Product / Process Change Notification (PCN)

PCN #: PCN_IndMAIA_20210130

Affected Series: WE-MAIA; 784383xxx

PCN Date: October 30, 2020

**Classification Reflow Profile for SMT components:****Classification Reflow Soldering Profile:**

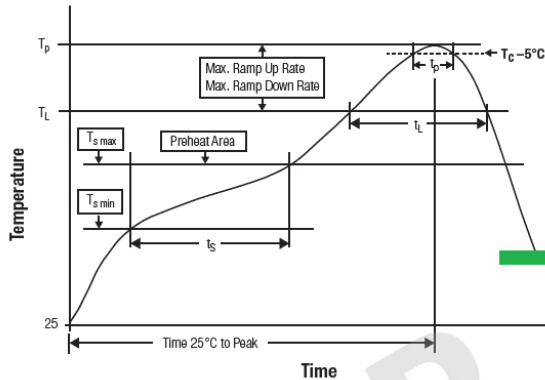
The recommendation as follows:

“Make sure that you use the correct thickness of solder paste to avoid an insufficient soldering result. We recommend 100µm solder paste as a reference.”

Will be implemented under the Classification Soldering Profile and in the Cautions and Warnings.

Make sure that you use the correct thickness of solder paste to avoid an insufficient soldering result. We recommend 100µm solder paste as a reference.
